**KURY HOMES
FINAL ENVIRONMENTAL IMPACT STATEMENT (FEIS)**

TOWN OF CLARKSTOWN, ROCKLAND COUNTY, NEW YORK

Prepared By: TIM MILLER ASSOCIATES, INC.
10 North Street
Cold Spring, NY 10516
Attention: Ann Cutignola, AICP - Senior Planner
(845) 265-4400
<http://www.timmillerassociates.com/publicreview>

August 1, 2010

Figure 1: 11 Lot Cluster Plan
 Kury Homes FEIS
 Town of Clarkstown, Rockland County, NY
 Source: Atzl, Scatassa & Zigler P.C.
 Full Size Drawing Number 1
 Drawing Date: 01/23/08, revised 07/16/10
 Scale: 1" = 100'

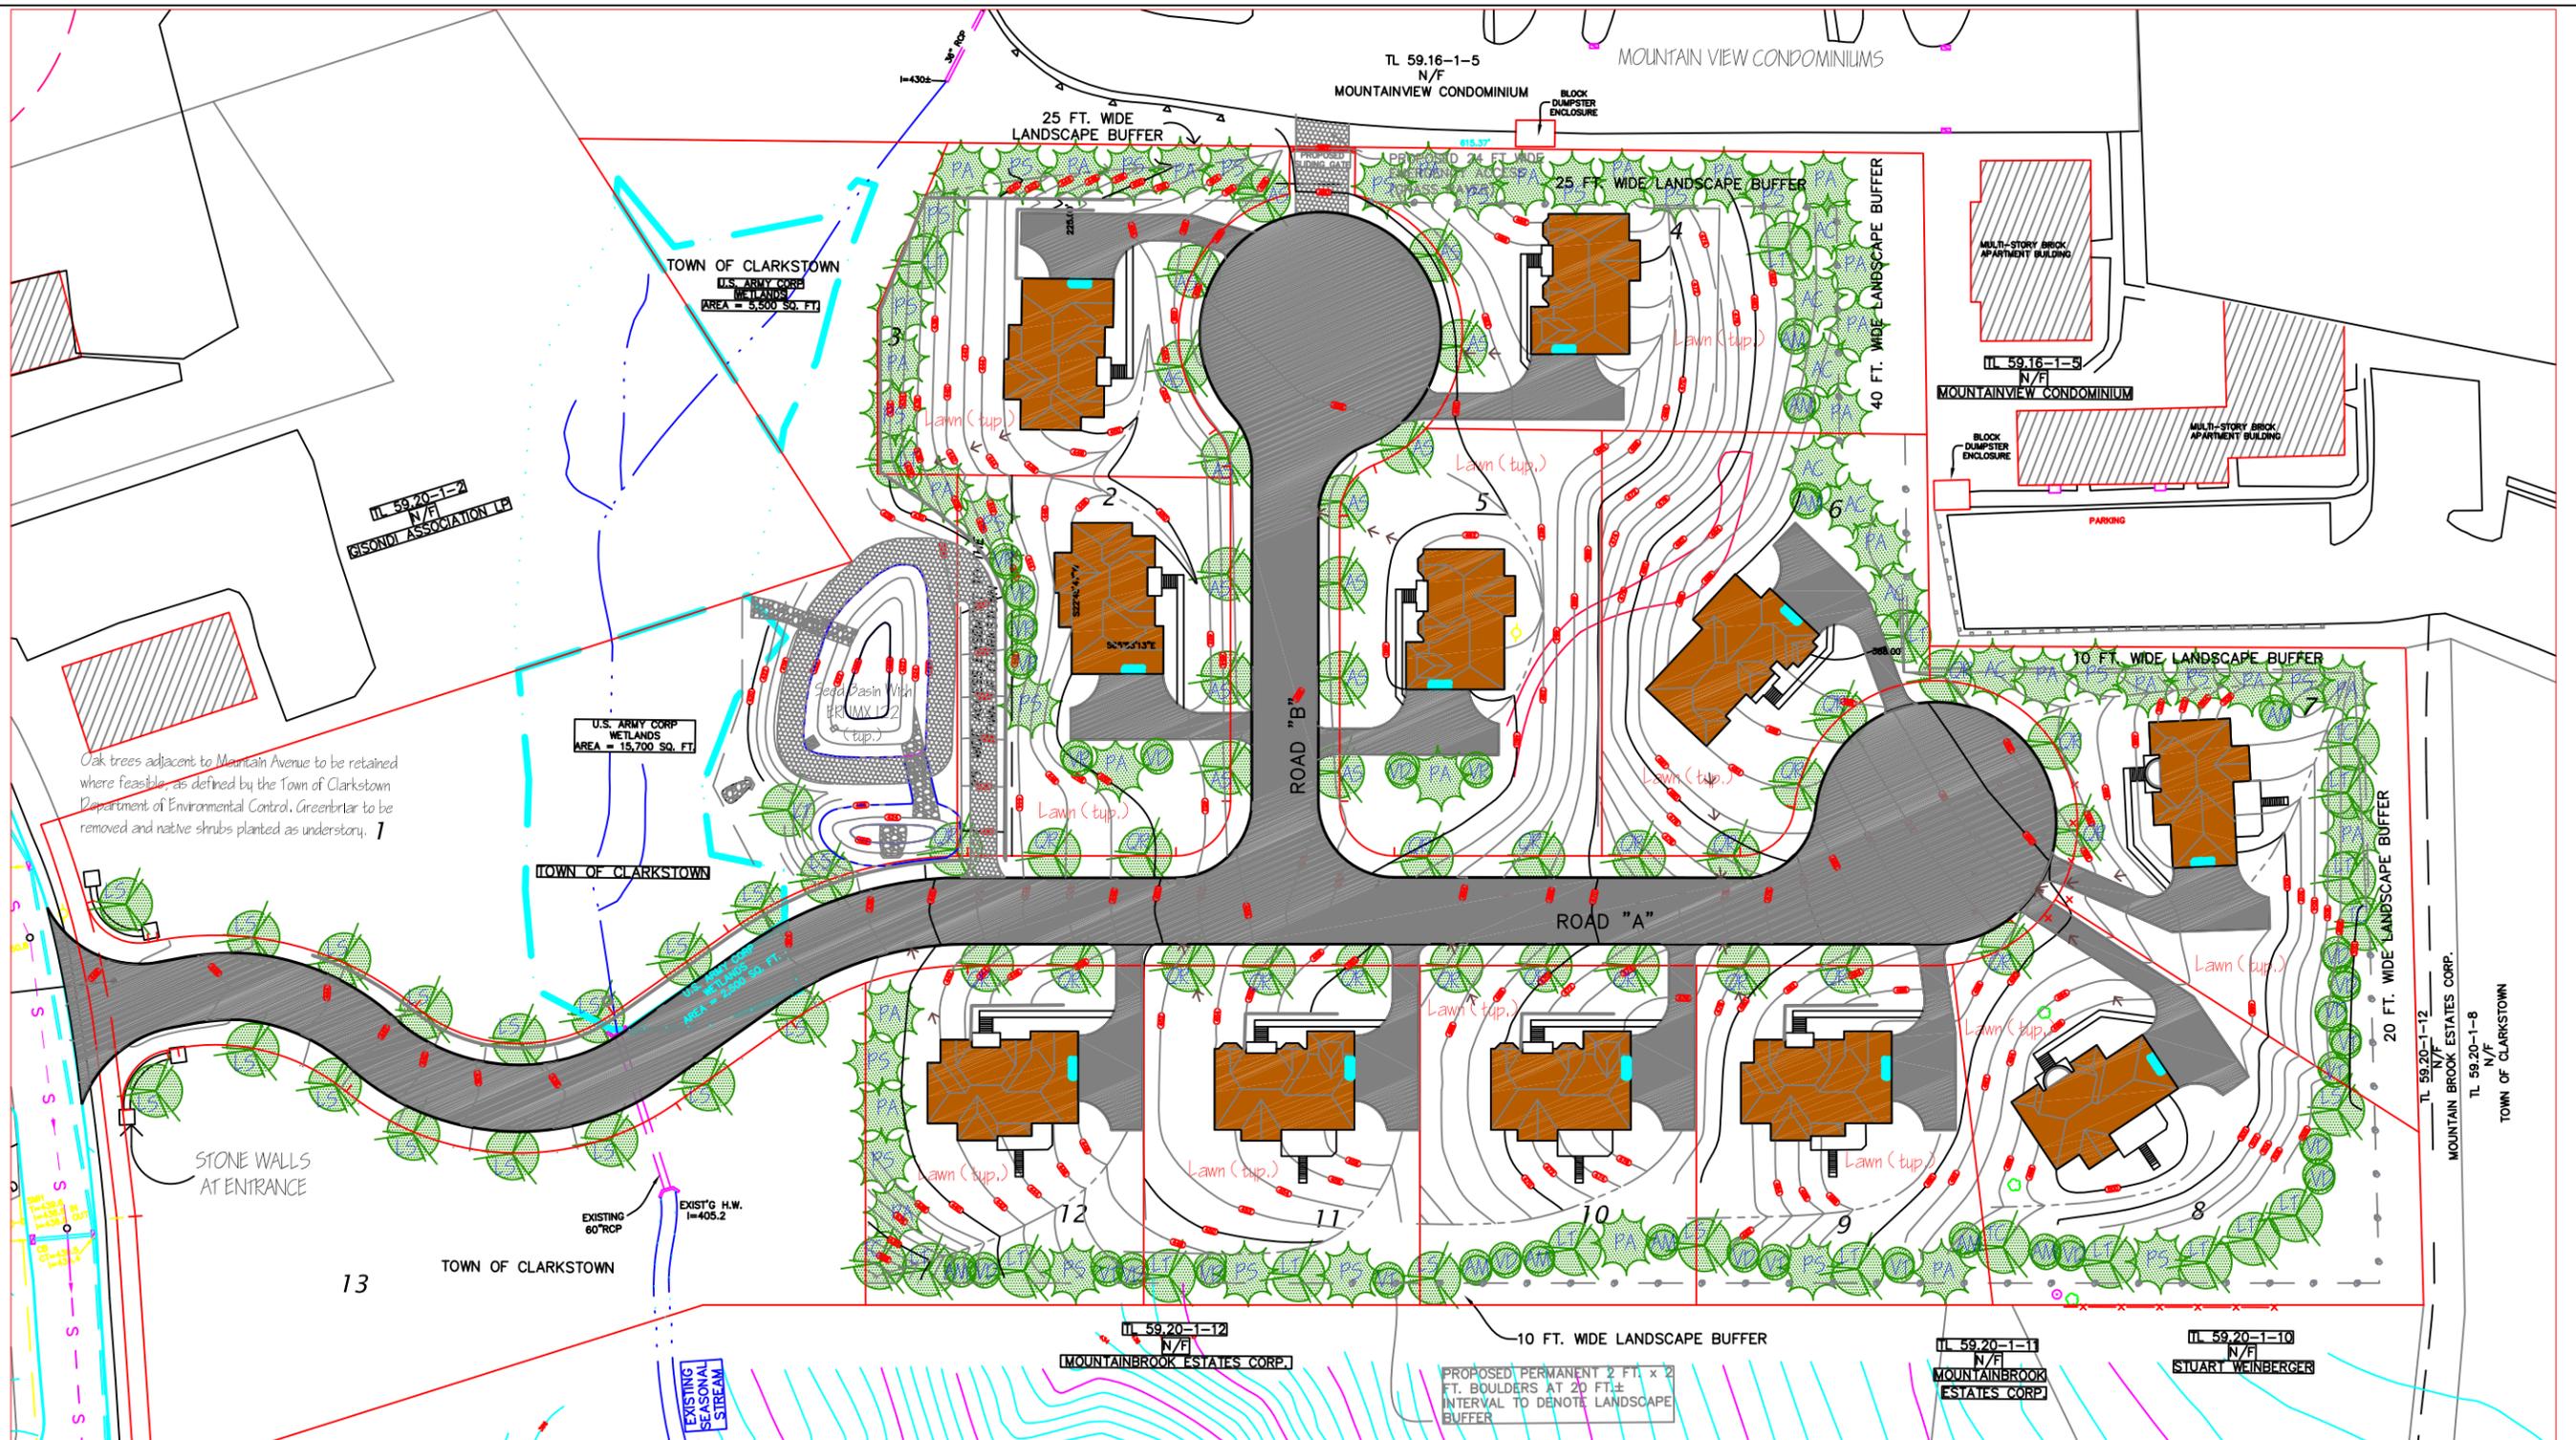
Comment 3.0-1 (Public Hearing, May 10, 2006, Marvin Baum, Member Town of Clarkstown Planning Board): This is just a view showing a steep slope coming off down to Forest Ridge down here, and I am assuming based on what is being proposed here, if you are going to have to elevate the road significantly, how far would the road have to go in order to conform to town standards?

Comment 3.0-2 (Public Hearing, May 10, 2006, Marvin Baum, Member Town of Clarkstown Planning Board): If you are in the current driveway, you can barely see. Even if some of the trees are cleared out here, because of the shape of the road and the dip in the road here, you can't really see who is coming and they can't see you properly.

I can actually tell you what the mitigation for this would be, which would be to shift the roadway closer to this telephone pole that is over there. You can get a good view. People are coming uphill, they have a better chance of stopping than they do when they are coming down hill, and so that would require some change in design to make it safe.

Comment 3.0-4 (Public Hearing, May 10, 2006, Dennis M. Letson, P.E., Deputy Director, Town of Clarkstown Department of Environmental Control): At this point there is a single bulk table on the standard layout subdivision plat that provides the zoning requirements for the R-22 District with a note that is there to see Sheet Six for the lot calculations based on the cut and fill plan, so that would have to be combined, and the areas that are listed here as impeded area with a note that includes the wetland, the hundred year flood plane, overhead utilities, mid rock outcrops and slopes between 30 and 50 percent, you know, I would suggest there are a number of figures in the document with the slope areas and the cuts and fills could be shown and broken out into figures within the document so that they are more easily discernible, and then you can make your determination and perhaps in this bulk requirements, A, that the bulk table here should be on the subdivision plat, not on the cut and fill plan, and I would suggest that the reductions be broken out, because the reductions are different for the different various lots, and instead of having a total impeded area figure shown, you have slopes 15, or 30 to 50 percent, slopes over 50 percent, wetland areas, and that the appropriate reduction be taken and shown in each of those individual columns.

Comment 3.0-19 (Letter #10, July 24, 2007, Robert Geneslaw, AICP, Planning Consultant, Town of Clarkstown): We suggest the driveways for lots 8 & 9 access the northerly cul de sac if possible.

Comment 3.0-22 (Letter #10, July 24, 2007, Robert Geneslaw, AICP, Planning Consultant, Town of Clarkstown): As the plan progresses, sight distances along Mountainview Avenue should be shown.

Response 3.0-1: The Road bed will have to be elevated approximately 20 feet in order to provide a reasonable road grade and a fairly level intersection with Mountainview Avenue.

Response 3.0-2: In the 11 lot Cluster Preferred Alternative, dated May 24, 2010, the driveway has been relocated to the north by approximately 50 feet. This has resulted in an increase in the available sight distance, which would be approximately 650 feet to the north and 630 feet to the south. A prevailing speed study was conducted on Mountainview Avenue on August 13, 2008, which established the 85th percentile of prevailing vehicle operating speed as 36 miles per hour for both northbound and southbound traffic. The available sight distance at the proposed access to Mountainview Avenue will meet the American Association of State Highway and Transportation Officials (AASHTO) requirements for intersection sight distance for vehicles traveling up to 55 miles per hour.

***Response 3.0-4:** A bulk table, listed by individual lot, which shows the net lot area after deductions for areas of steep slope and wetland area, including the lot specific FAR coverage has been included on the 11 lot Cluster Preferred Alternative, dated May 24, 2010.*

Response 3.0-19: The 11 lot Cluster Preferred Alternative, as shown on the Engineering Plans prepared by Atzl Scatassa and Zigler, dated May 24, 2010, includes a redesign and lot renumbering. The lots which are located off Road B, the northern cul-de-sac, now have their driveway access onto Road B.

Response 3.0-22: The 11 lot Cluster Preferred Alternative, dated May 24, 2010 subdivision plat includes noted sight distance of 650 feet to the north and 630 feet to the south. (Refer to Response 3.0-2 for a discussion of sight distance adequacy.)

Figure 3: 11 Lot Cluster Grading Plan
 Kury Homes FEIS
 Town of Clarkstown, Rockland County, NY
 Source: Atzi, Scatassa & Zigler P.C.
 Full Size Drawing Number 2
 Drawing Date: 01/23/08, revised 07/16/10
 Scale: 1" = 100'

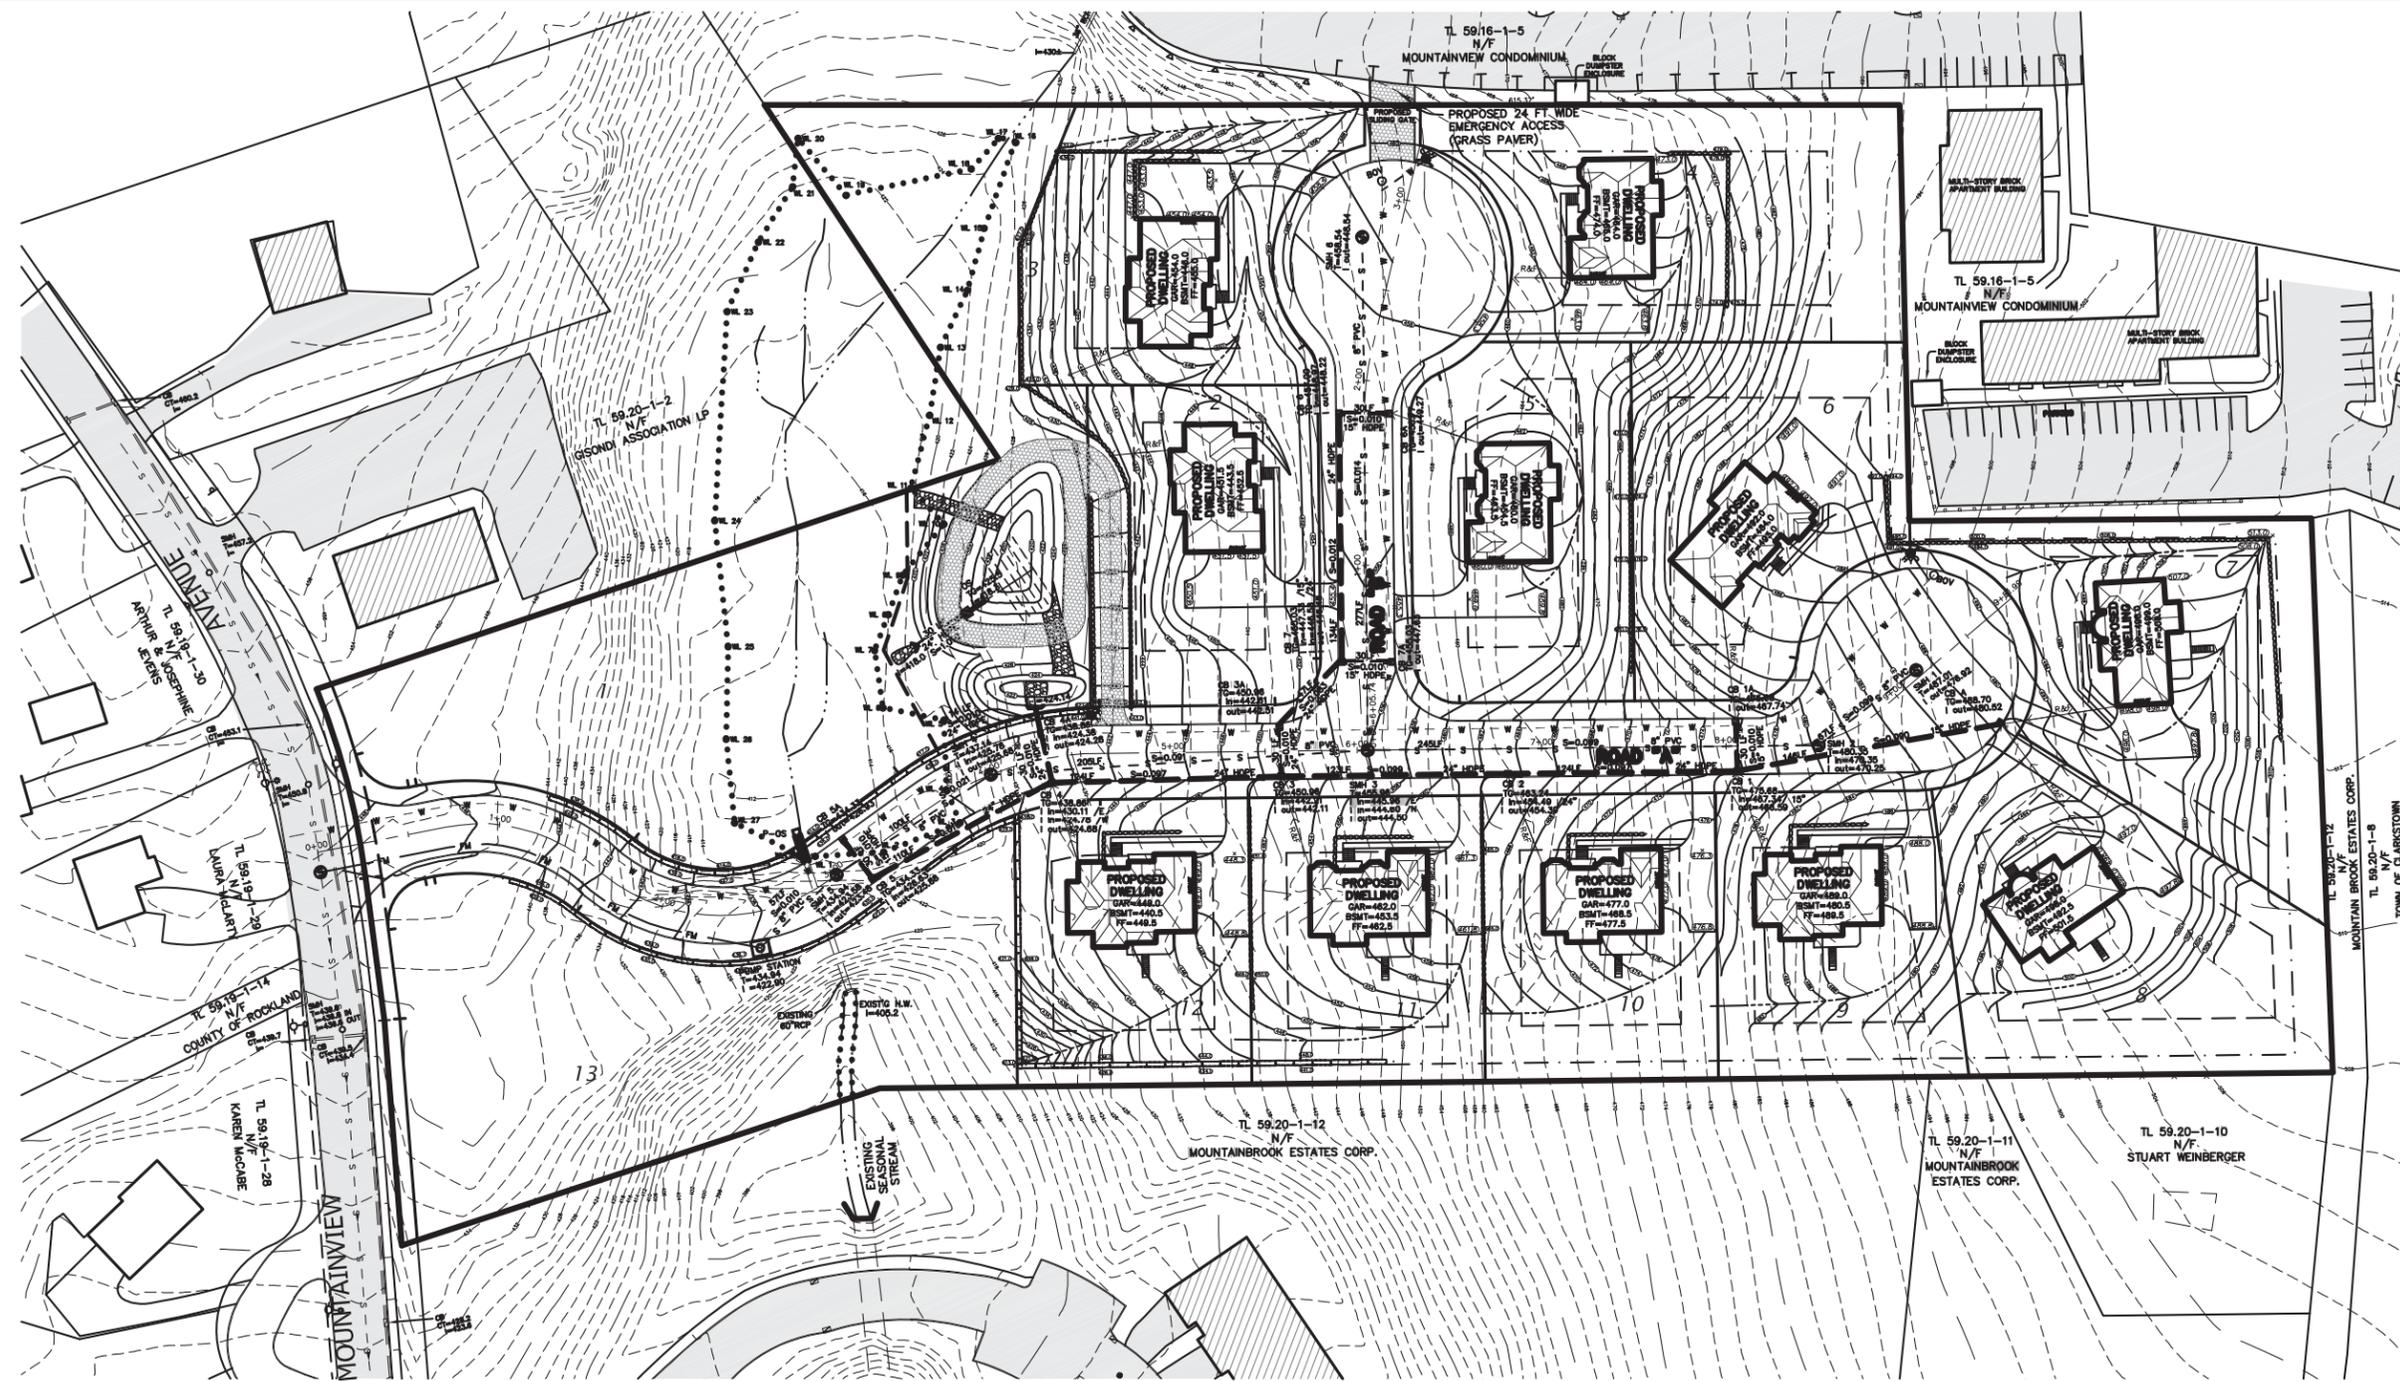
Comment 3.0-18 (Letter #10, July 24, 2007, Robert Geneslaw, AICP, Planning Consultant, Town of Clarkstown): It would be helpful to have a plan with topo and a conceptual grading plan.

Comment 3.0-53 (Public Hearing, July 22, 2009, Robert Geneslaw (via letter read by Rudolph Yacyshyn), AICP, Planning Consultant, Town of Clarkstown): 7. The legend on Drawing 2 should include reference to all patterns used on drawing, i.e., cross hatch and solid black areas in lots 1 and 13.

Comment 3.0-54 (Public Hearing, July 22, 2009, Robert Geneslaw (via letter read by Rudolph Yacyshyn), AICP, Planning Consultant, Town of Clarkstown): 8. Consideration should be given to a drop curb at the ends of the emergency access, see Drawing 2.

Comment 3.0-55 (Public Hearing, July 22, 2009, Robert Geneslaw (via letter read by Rudolph Yacyshyn), AICP, Planning Consultant, Town of Clarkstown): 9. Many of the lots have almost no relatively flat backyard space for family use. See Drawing 2.

Response 3.0-18: The DEIS Addendum dated July 1, 2009, included a full set of full size plans for the 11 lot Cluster Alternative, dated May 24, 2010 including grading and an erosion control plan, also dated May 24, 2010.

Figure 4: Tree Preservation Plan
 Kury Homes FEIS
 Town of Clarkstown, Rockland County, NY
 Source: Atzl, Scatassa & Zigler P.C.
 Full Size Drawing Number 5
 Drawing Date: 01/23/08, revised 07/16/10
 Scale: 1" = 100'

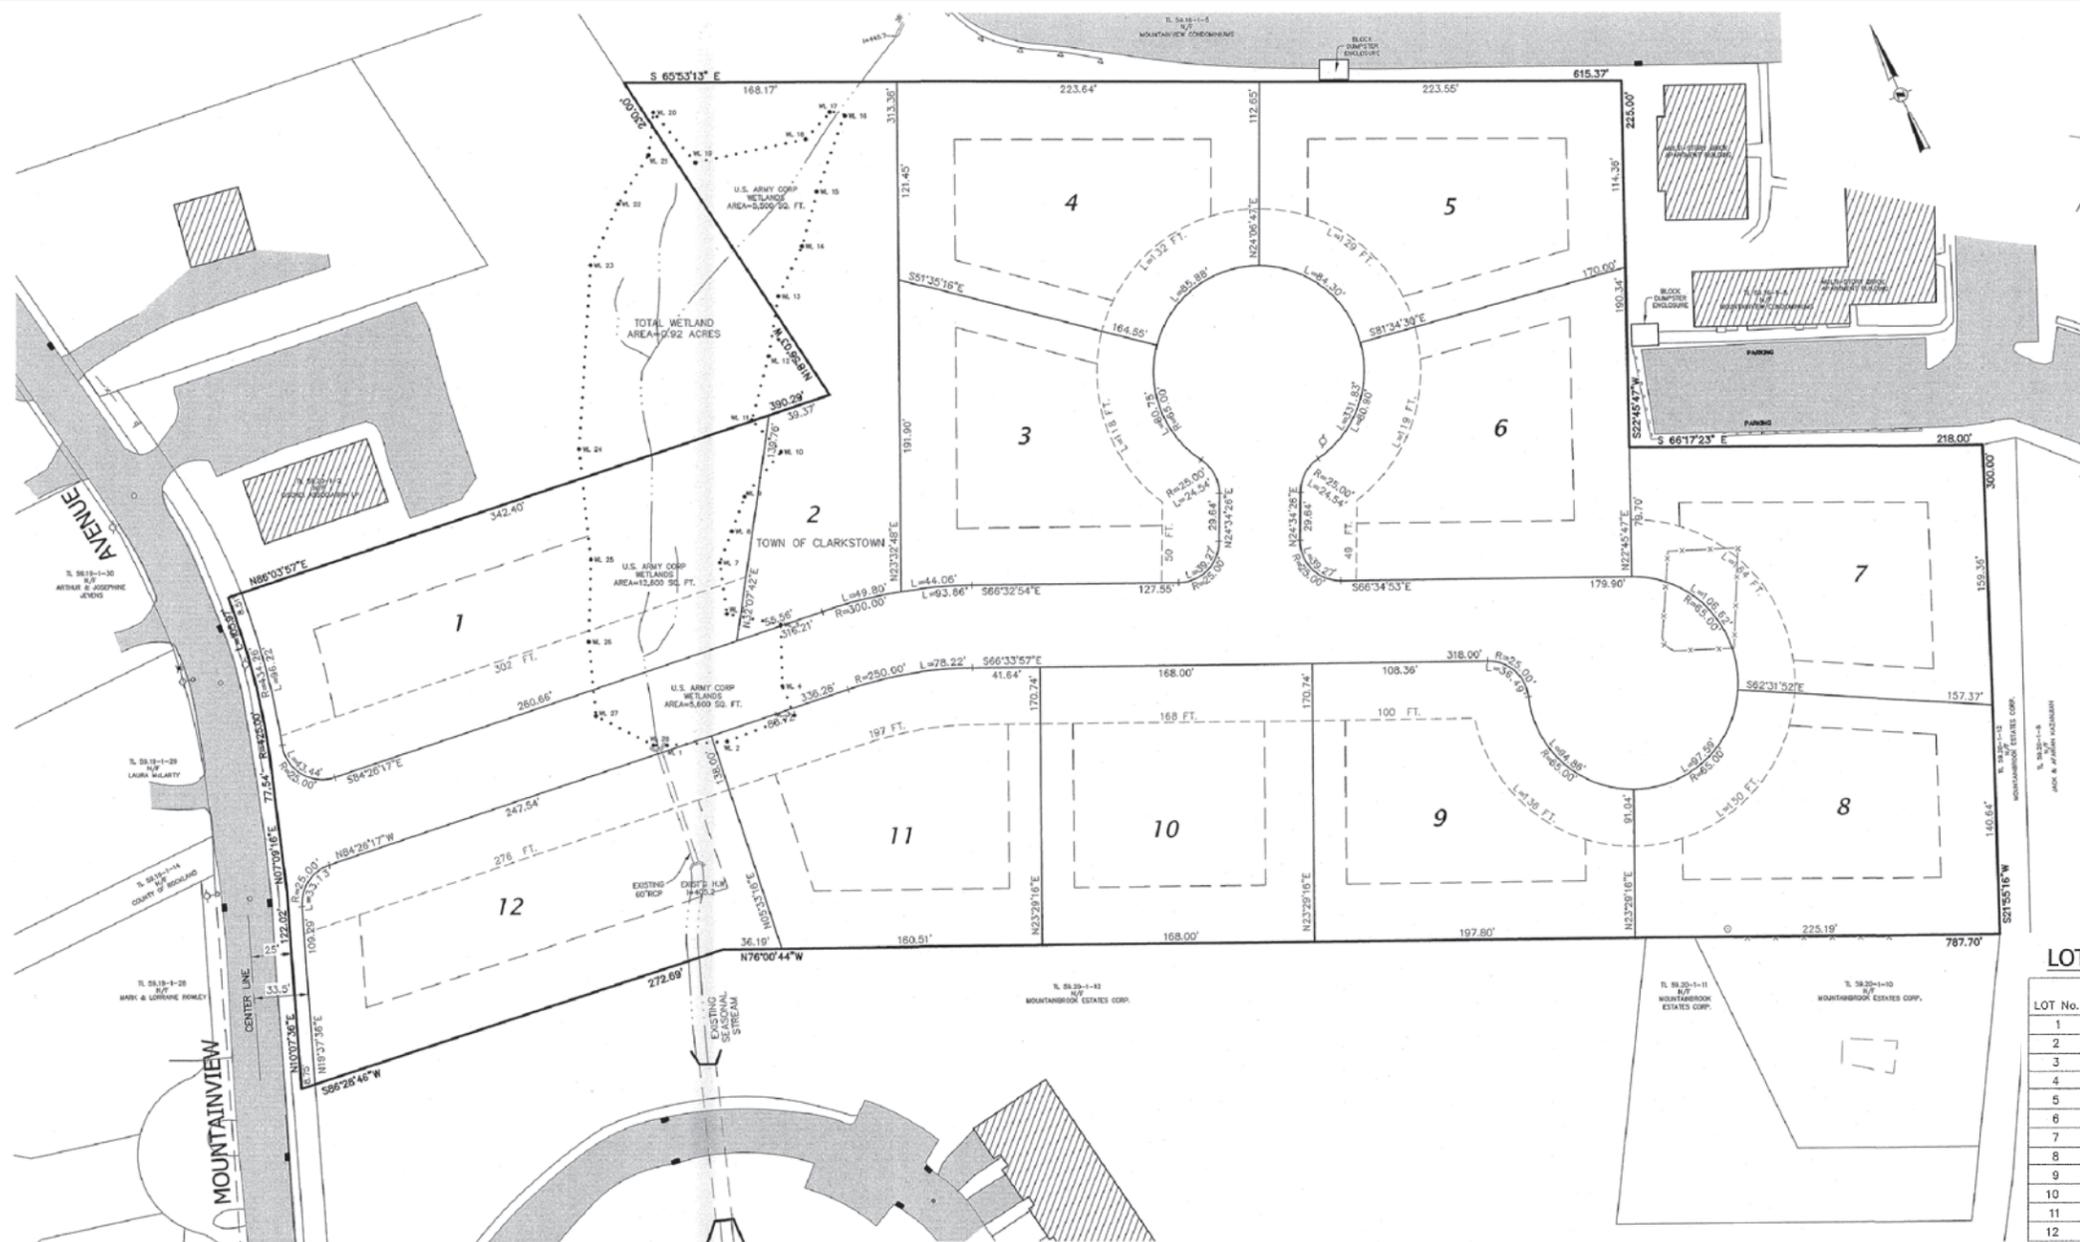
Comment 3.0-14 (Letter #9, July 10, 2007, Charles Maneri, Building Plans Examiner, Town of Clarkstown Building Department): The buffer areas should be delineated so future homeowners do not remove any trees in these areas.

Response 3.0-14: On the 11 Lot Cluster Preferred Alternative, dated May 24, 2010 the Landscape buffers are delineated as follows:
